# MCK0590 and MCK0592

## NEW TENSIONER

A new version of the tensioner contained in kits MCK0590 and MCK0592 is available.

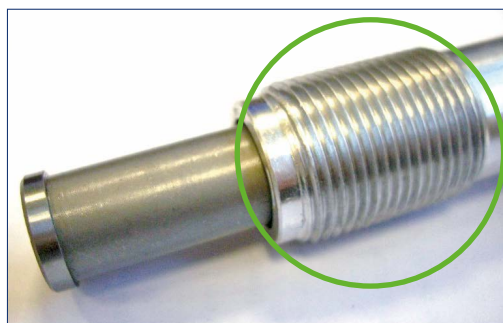
The previous tensioner, part number **OE 11317797901** (shaft length 63 mm, overall length 86 mm) has been substituted by a new version, part number **OE 11318586699** (shaft length 66 mm, overall length 90 mm).

There are two differences between the versions:

1. The threaded section (M22 x 1.5 mm) has been elongated and now extends to the end of the shaft.
2. The plunger is longer (just a few millimetres).

This image shows the housing of the tensioner on the head.

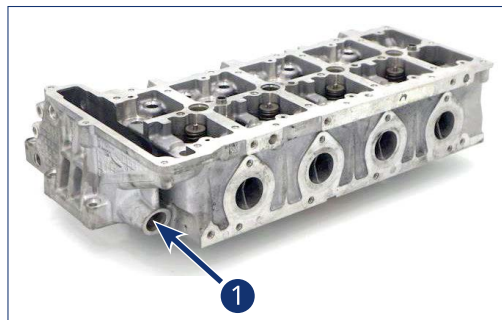
**On a limited number of vehicles**, this variation in length of the threaded shaft will require the housing on the head to be modified. This modification will be necessary in order to be able to correctly fit the tensioner.

In the event that when installed into the head, the base of the tensioner (new version) protrudes, it will be necessary to modify the housing by extending the thread.

- Use a threading tool with the following characteristics: M22 x 1.5 mm.
- Rethread the hole, extending the thread for the entire length of the hole (the thread must extend from one end to the other).
- Remove any shavings from the thread and carefully clean the head.
- Reinstall the tensioner, verifying that the surfaces couple.
- Tighten the tensioner to 70 Nm.

Lastly, carefully clean the surfaces to ensure that no debris can enter the engine and the lubrication system.
